ALLAMAKEE CSD MIDDLE SCHOOL HVAC UPGRADE
WAUKON, IOWA

ADDENDUM 01
March 2, 2026

ME101

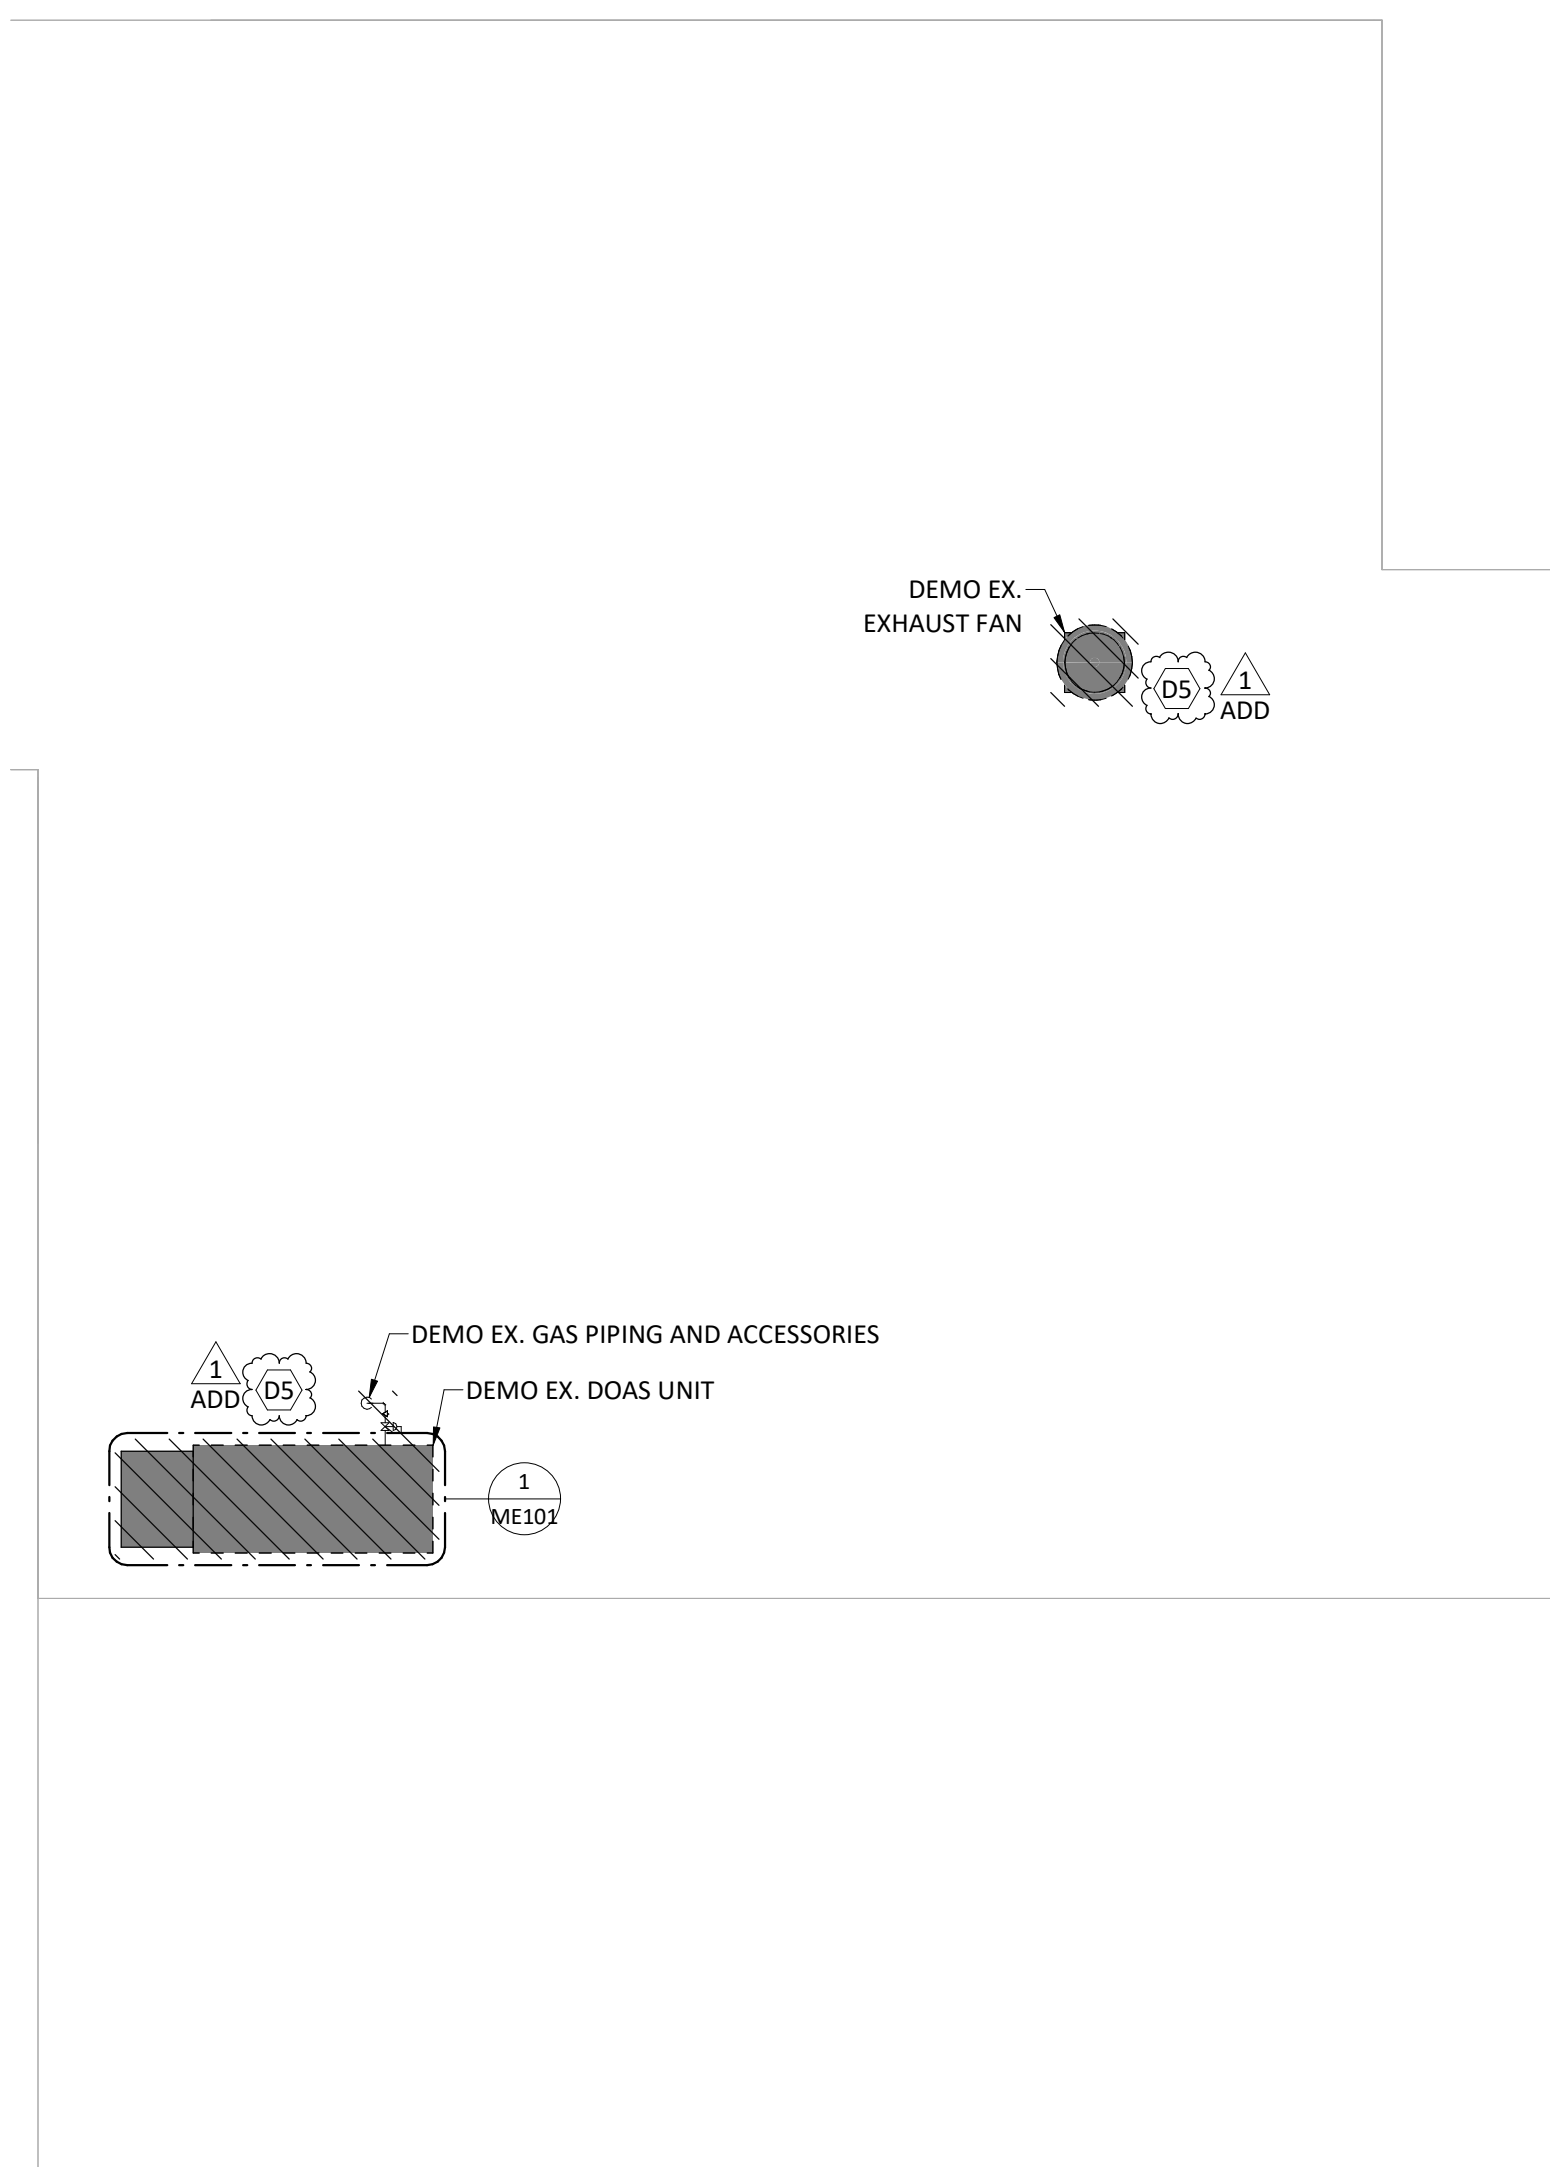
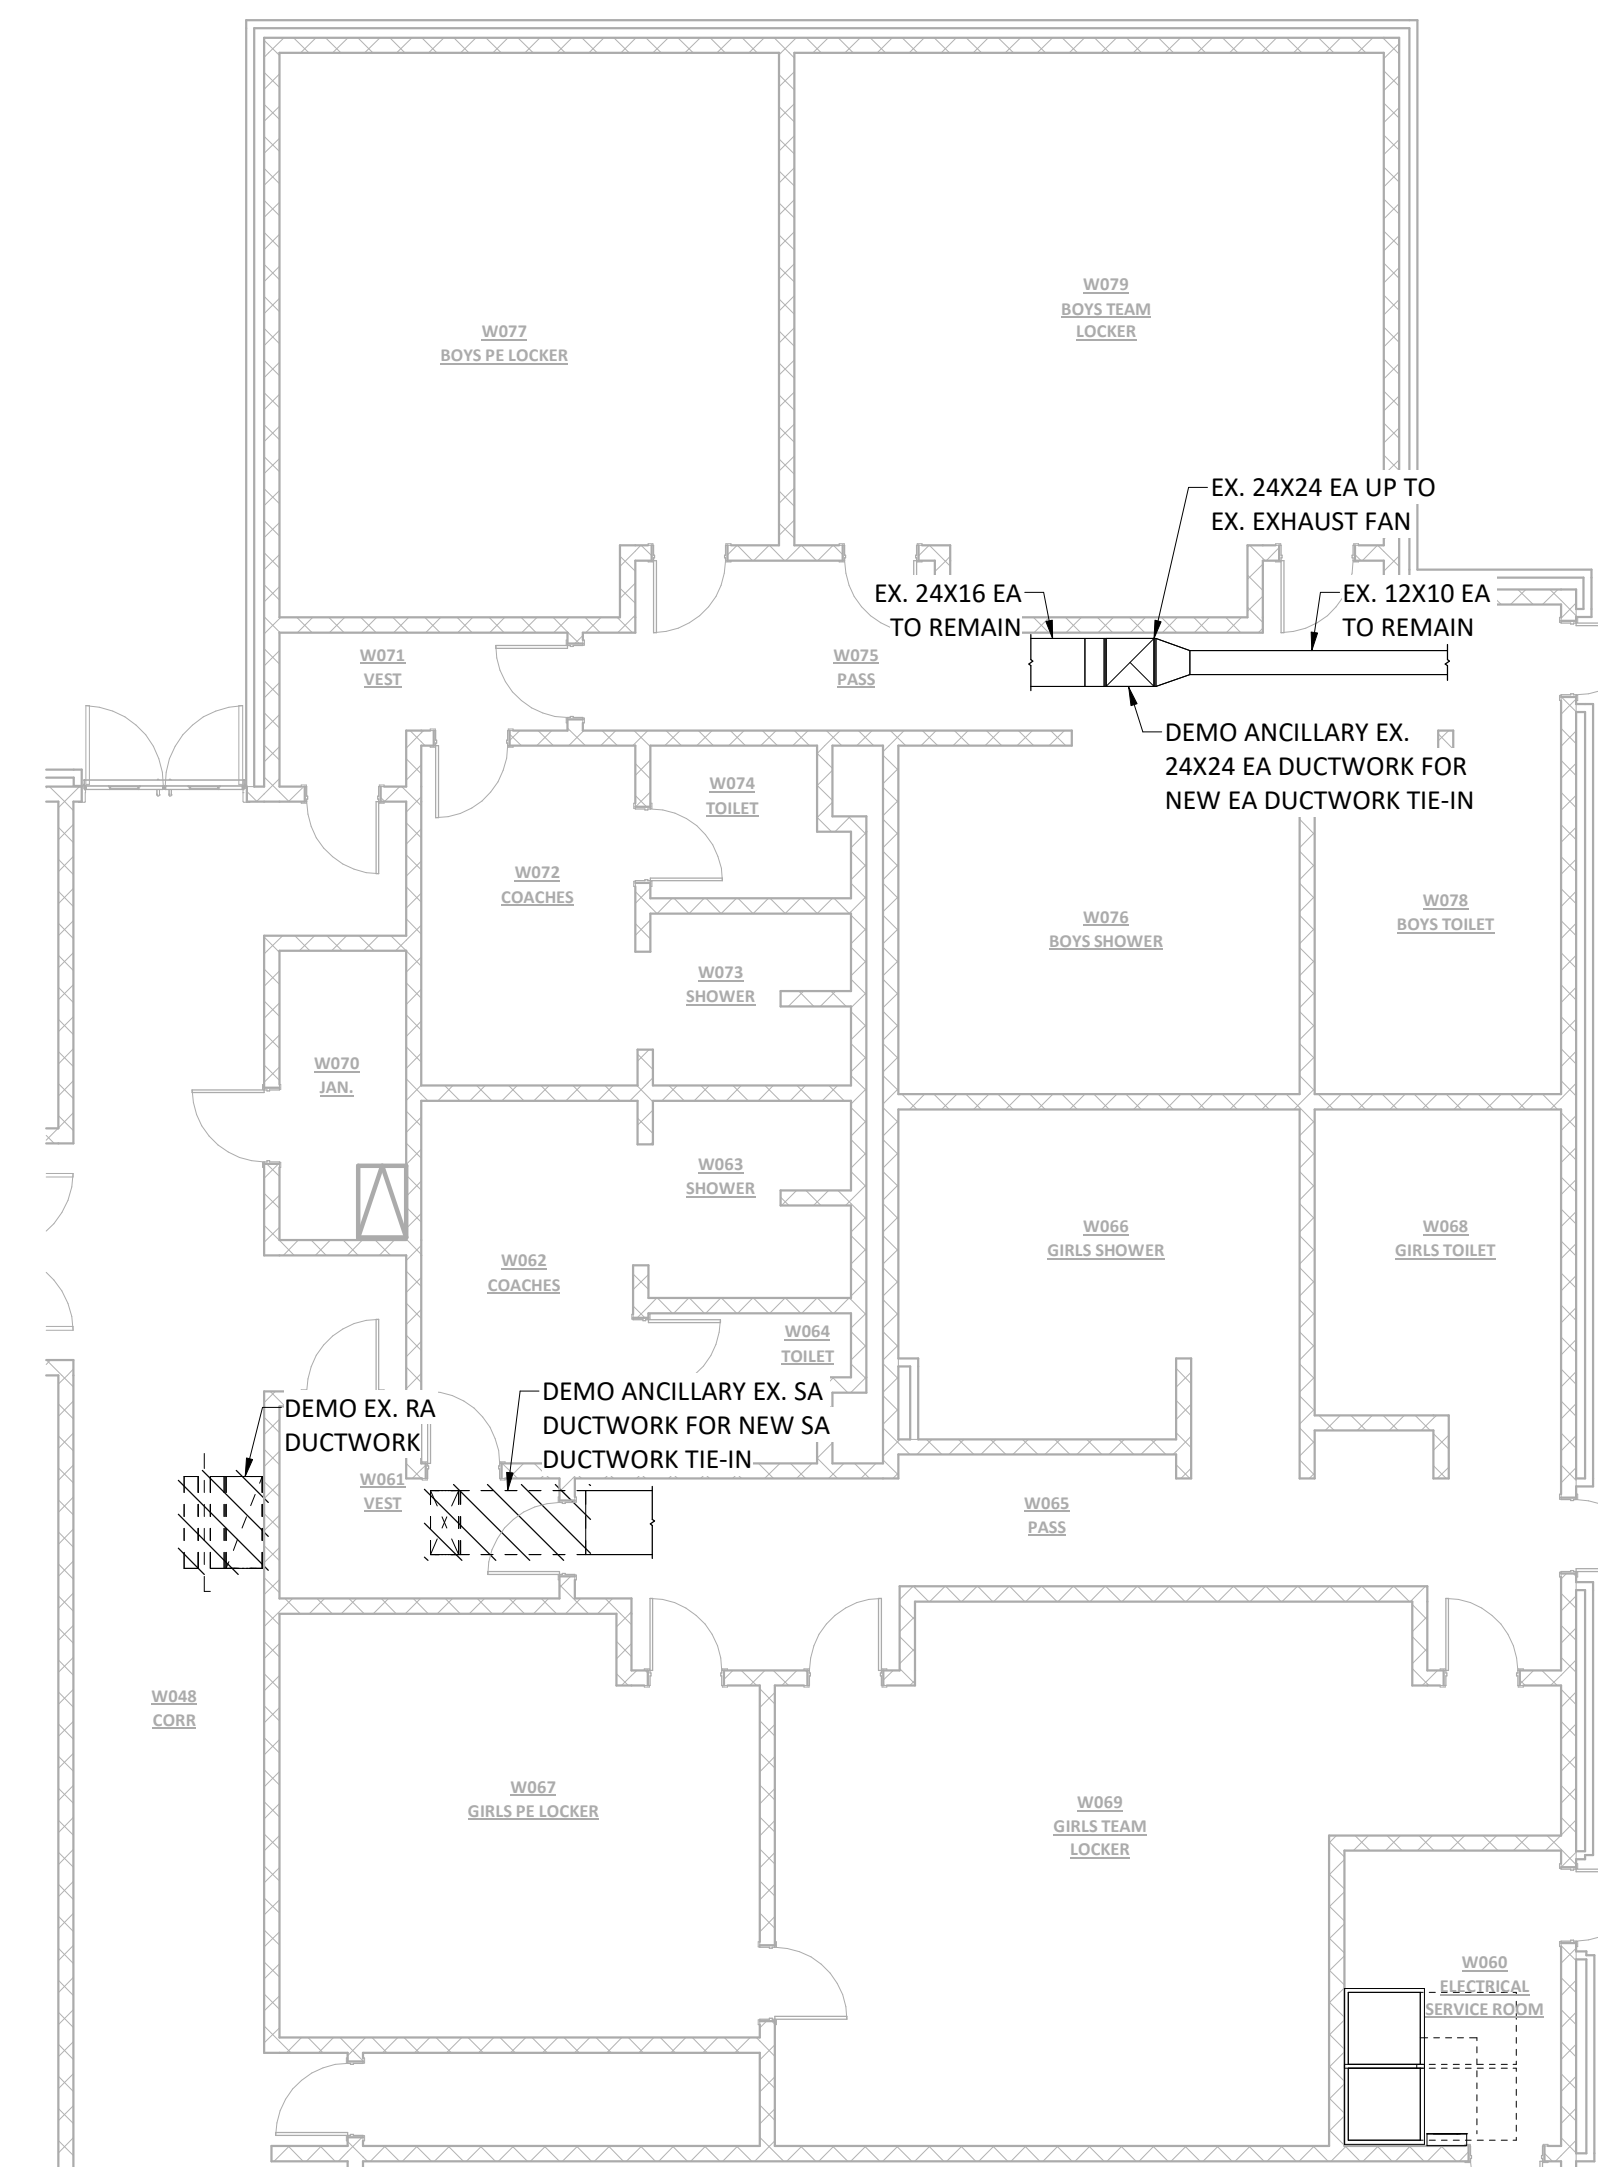
1. Added electrical demo keynote D5 to existing DOAS unit and existing exhaust fan above the high school.
- ME1-2 Drawing **ME102 – MECHANICAL & ELECTRICAL PLANS – HIGH SCHOOL**

MECHANICAL & ELECTRICAL PLAN - EAST ELEMENTARY
1/8" = 1'-0" N

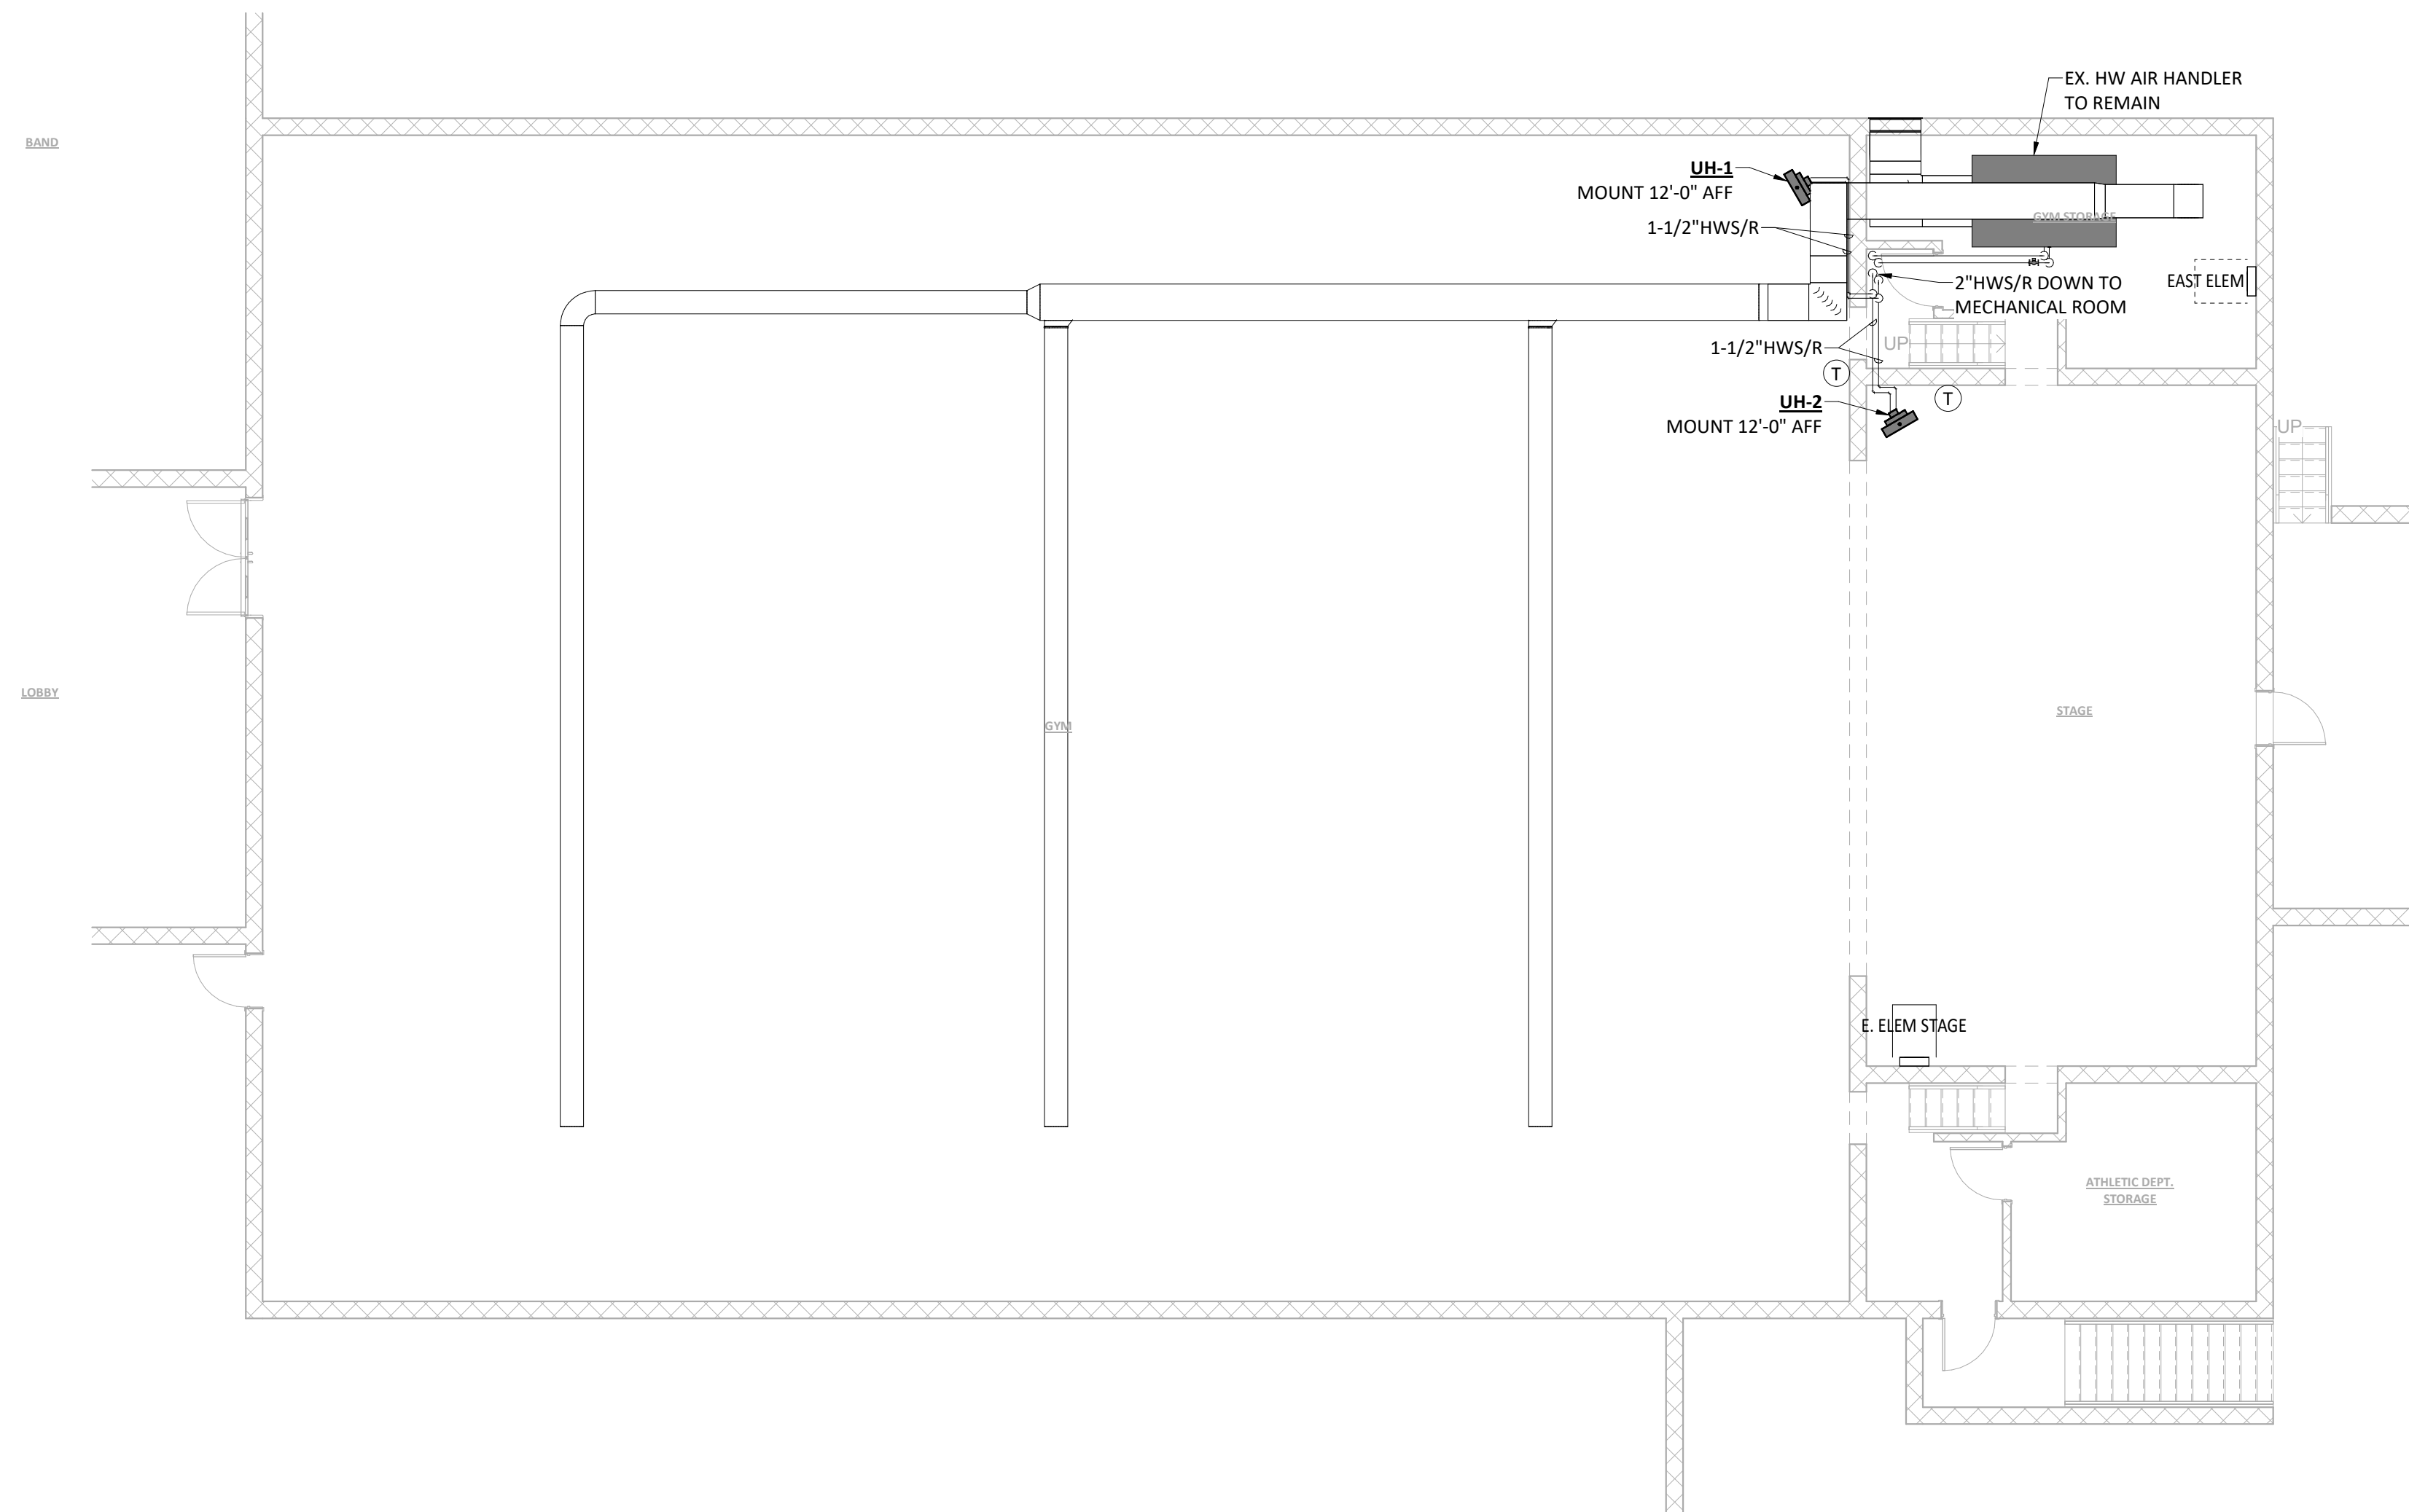
1. Added thermostat and smoke detector.
- ME1-3 Drawing **ME103 – MECHANICAL & ELECTRICAL PLANS – EAST ELEMENTARY**
1. Added clarification which specifies that disconnects for the proposed unit heaters shall be provided by the mechanical contractor.

2. Revised entering water temperature (EWT) of UH-1 and UH-2.
